Carolina Power & Light Company

RE: DOCKET NOS. 50-400, 50-401, 50-402, AND 50-403

Shearon Harris Nuclear Power Plant
Plant Buildings Exhaust Systems

Shearon Harris Nuclear Power Plant
Revisions to the Secondary Liquid Waste Processing System

FIGURE 1

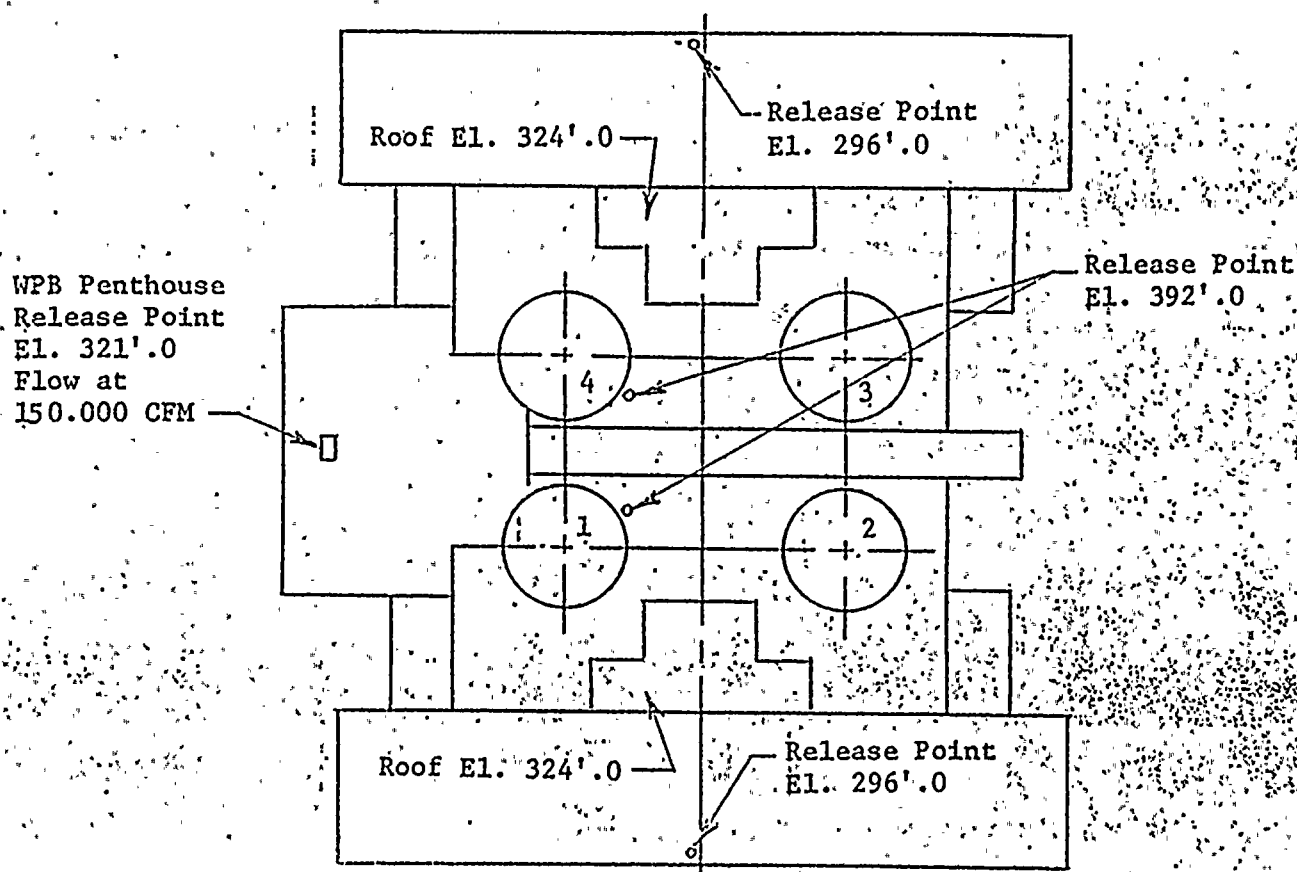
One stack per two units is located on the inboard side of Reactor Containment Building Nos. 1 and 4. The top of the stack is located approximately 16 feet above the Reactor Containment Building spring line approximately 132 feet above Grade Elevation (260 feet). The stack diameter for Unit Nos. 1 and 2 is 13 feet (10 feet for Unit Nos. 3 and 4) with the exhaust inlet to stack located at 21 feet above grade elevation.

Normal air flow through the stacks is shown on Figure 1 with a temperature range of 60° to 120°F. This includes flow from two reactor auxiliary building fans (one per unit), containment purge fans (one per unit), and normal fuel handling building exhaust (Unit Nos. 1 and 2 stack only).

1. Release point at RCB Unit 1, El. 392'

Flow: 365,000 CFM Min. to 475,000 CFM Max.

2. Release Point at RCB Unit 4, El. 392'

Flow: 270,000 CFM Min. to 310,000 CFM Max.

3. Release Point at Border Line of TB Units 1&2, El. 296'

Flow: 20,000 CFM.

4. Release point at border line of TB Units 3&4, El. 296'

Flow: 20,000 CFM.

Figure 1

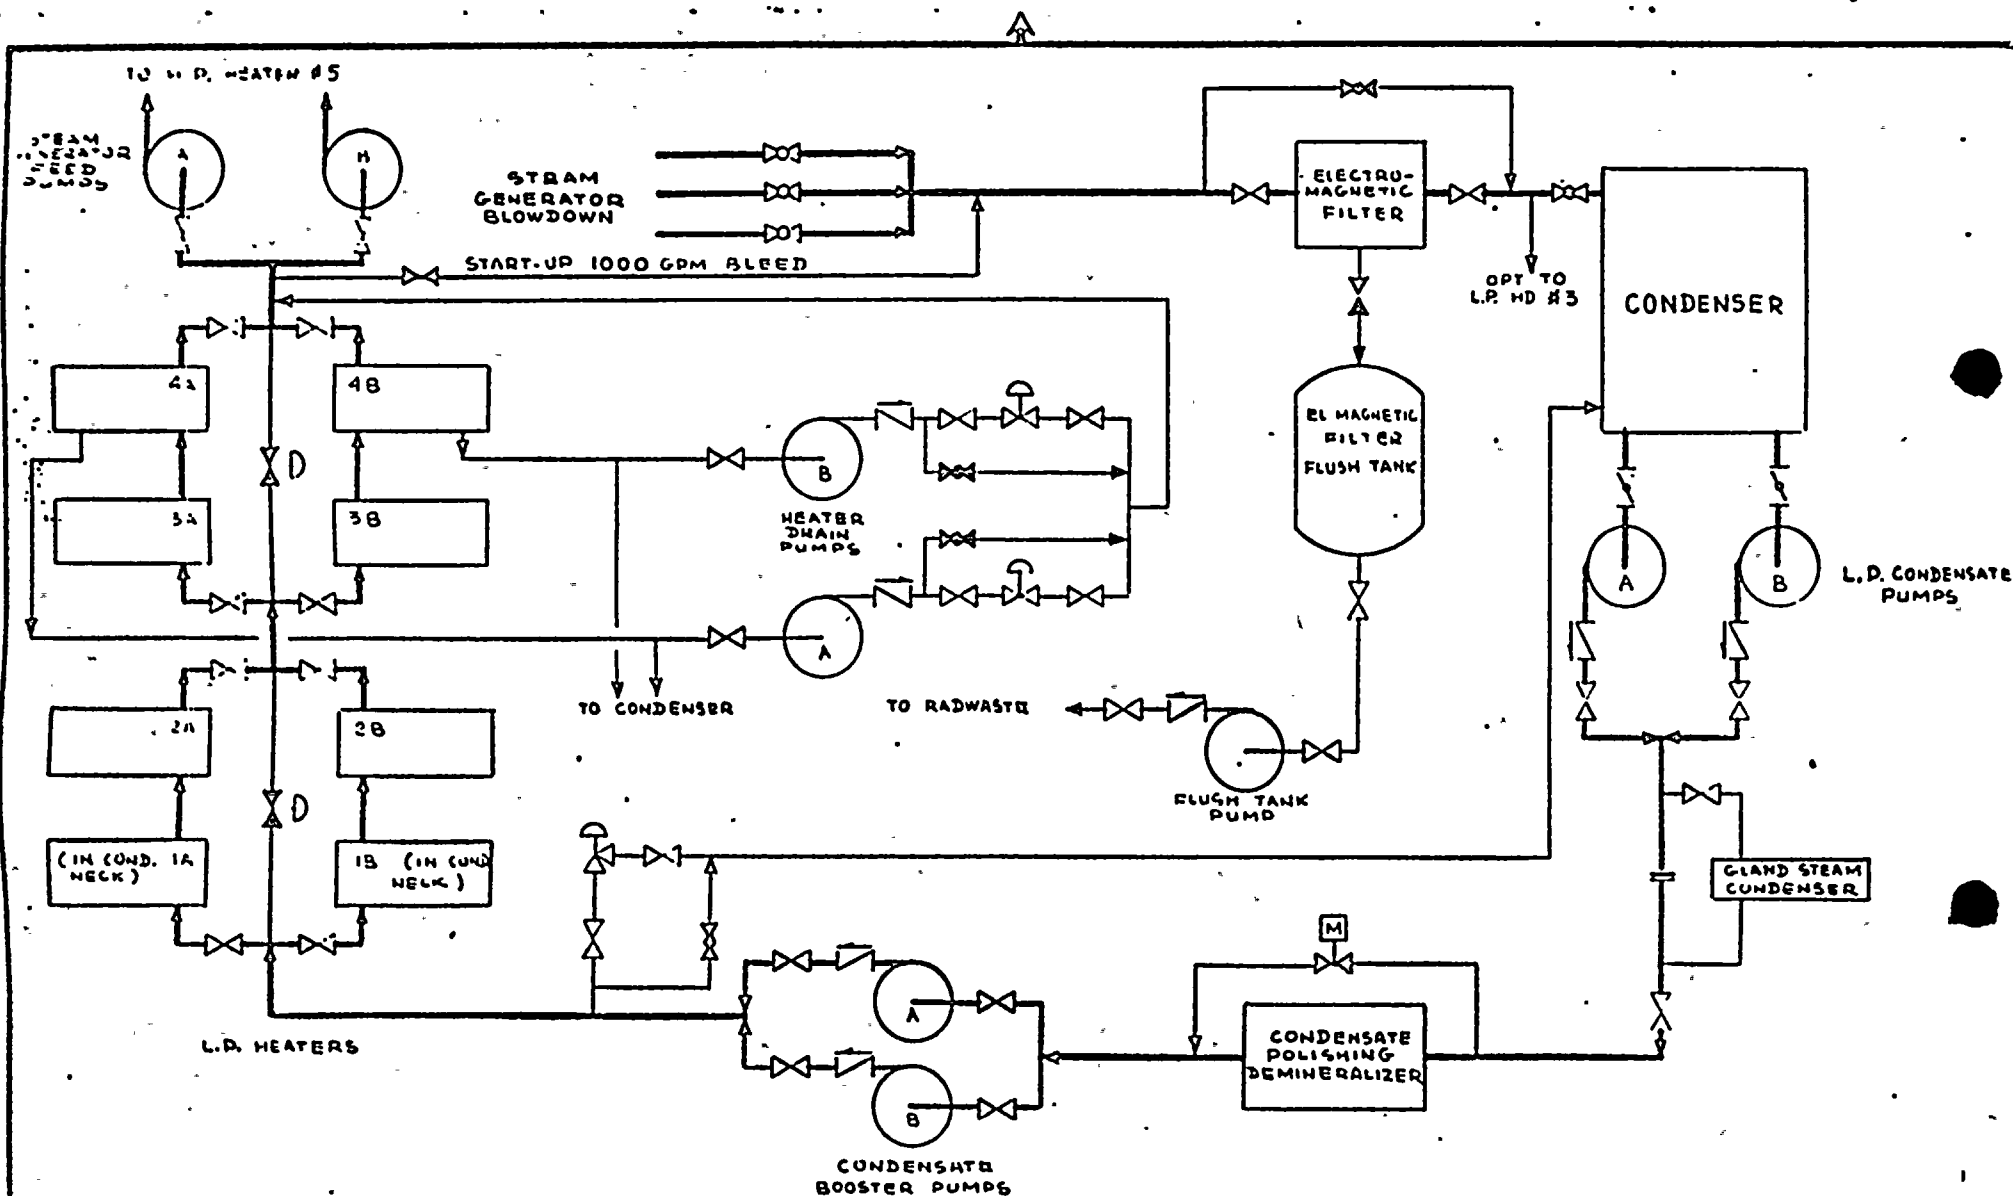
For a pressurized water reactor having recirculating U-tube steam generators and employing all volatile treatment (AVT) to main secondary coolant chemistry, provide the following information:

- a. Expected blowdown rate (lb/hr) and method of processing blowdown.
- b. Number and type of condensate demineralizers (if applicable) and flow rate of condensate through polishing demineralizers (lb/hr).
- c. Expected frequency of resin regeneration or replacement, volumes and radioactivity of regenerant and rinse solutions, sluice water, or backwash water per batch of resin regenerated or replaced.
- d. Method of collection, processing and disposal of liquid wastes, including decontamination factors assumed for process operations.
- e. P&ID's and process diagrams for the steam generator blowdown system and condensate polishing system.

- a. At full power, the mass of liquid in each steam generator is approximately 149,820 lb. The design blowdown rate is 2 percent of maximum guaranteed steam flow of 12,205,906 lb/hr or 244,118 lb/hr. Average blowdown is 37,500 lb/hr. The blowdown fluid is passed through an electromagnetic filter, which removes magnetic suspended solids, to the low pressure heater #3. The fluid subsequently cascades through LP heaters 2 and 1 to the condenser hotwell. Flush volumes from the electromagnetic filter are processed by the secondary liquid radwaste system. Figure 1 depicts the blowdown system.

- b. A full-flow condensate polisher, consisting of 7 mixed bed demineralizer vessels, each with a volume of 222 ft.³ (6 operating plus 1 standby) is capable of handling a normal flow of 8,426,000 lb/hr and a peak flow of 12,000,000 lb/hr. This normal condensate flow represents approximately 69% of the steam generator feedwater flow.
